<b>Well Name:</b> CO 10 15 FEDERAL	<b>Well Location:</b> T25S / R32E / SEC 10 / NENW / 32.150074 / -103.666167	<b>County or Parish/State:</b> LEA / NM
<b>Well Number:</b> 632H	<b>Type of Well:</b> OIL WELL	<b>Allottee or Tribe Name:</b>
<b>Lease Number:</b> NMLC061936	<b>Unit or CA Name:</b> COTTON DRAW UNIT	<b>Unit or CA Number:</b> NMNM70928X
<b>US Well Number:</b> 3002554205	<b>Operator:</b> CHEVRON USA INCORPORATED

**Notice of Intent**

**Type of Action:** APD Change

**Procedure Description:** CHEVRON USA INC REQUESTS THE FOLLOWING CHANGES ON CO 10 15 FEDERAL 632H (API# 30-025-54205) CHANGE THE POOL CODE AND POOL NAME OLD: POOL CODE- 96715 WC-025 G-06 S253209L;BONE SPRING NEW: POOL CODE- 98270 WC-025 S253216D; UPPER WOLFCAMP CHANGE LAST TAKE POINT LOCATION OLD: SECT 34 100' FNL 2310' FWL NEW: SECT 15 100' FSL 2530'FWL CHANGE BOTTOM HOLE LOCATION OLD: SECT 34 25' FNL 2310' FWL NEW: SECT 15 25' FSL 2530' FWL CHANGES TO PRODUCTION LINER: OLD: 5.5' 20# NEW: 5' 13# REQUESTING TO HAVE A CONTINGENCY OF 5.5' 17# SHOULD WE HAVE ANY ISSUES WITH USING THE 5'13# CHANGES TO THE SURFACE CASING SET DEPTH. PLEASE SEE ATTACHED NEW C102, 9 PT DRILL PLAN, CASING DESIGN AND DIRECTIONAL DRILL PLA

<b>CO 10 15 FEDERAL COM NO. 632H WELL</b>	<b>PROPOSED KICK OFF POINT</b>	<b>PROPOSED FIRST TAKE POINT</b>
X=747,815.69	X=748,703.71	X=748,706.00
Y=418,972.27	Y=420,232.87	Y=419,735.86
LAT.32.150075°N	LAT.32.153525°N	LAT.32.152158°N
LONG.103.666167°W	LONG.103.663272°W	LONG.103.663275°W

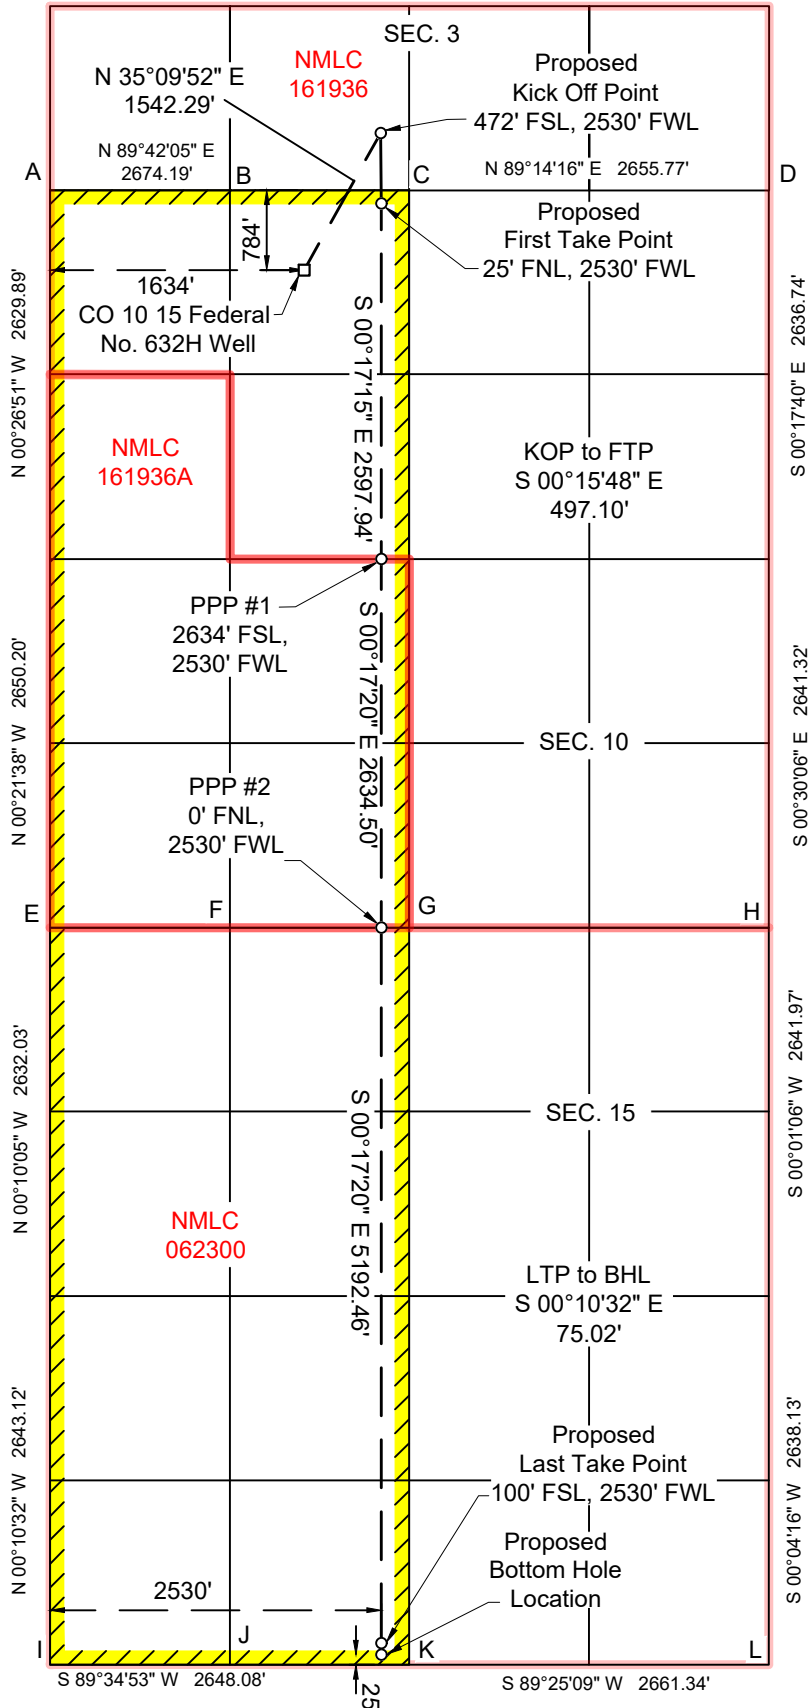
CHANGE LAST TAKE POINT LOCATION

OLD: SECT 34 100 FNL 2310 FWL

NEW: SECT 15 100 FSL 2530FWL

CHANGE BOTTOM HOLE LOCATION

OLD: SECT 34 25 FNL 2310 FWL

NEW: SECT 15 25 FSL 2530 FWL
